Safety Evaluation Report

Safety Evaluation Report Related to the Renewal of
the Operating License for the TRIGA Reactor at the
Oregon State University

September 2008

Office of Nuclear Reactor Regulation
U.S. Nuclear Regulatory Commission

Figure 12.1 Radiation Center organization

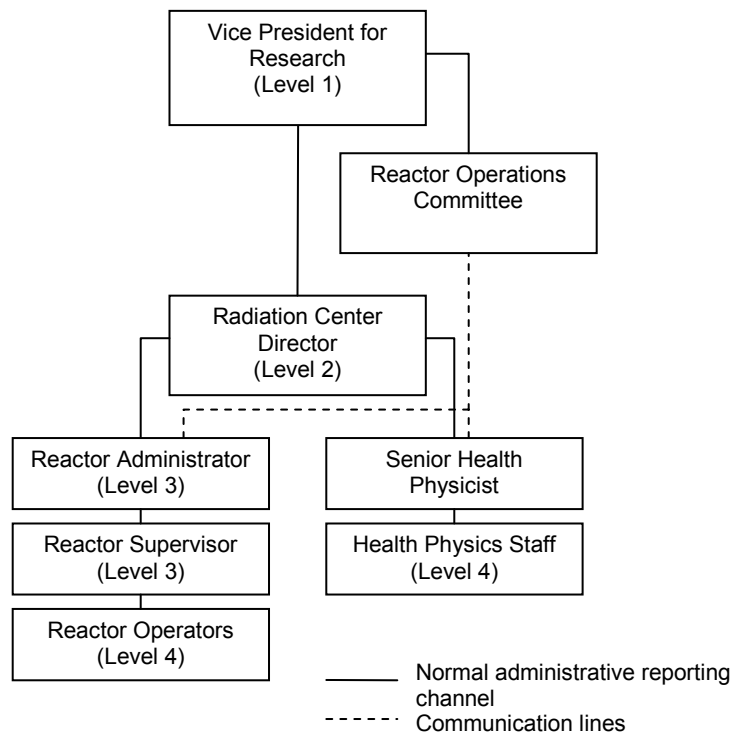
The facility organizational structure (Figure 12.1) shows that the ROC reports to the Vice President for Research which is considered a Level 1 position. The ROC conducts its review and audit functions in accordance with a written charter, which includes provisions for meeting frequency, voting rules, quorums, method of submission, content of presentations to the ROC, use of subcommittees, and minutes. The charter was reviewed and found to be in agreement with the SAR, NUREG-1537, and the recommendations of ANSI/ANS-15.1.
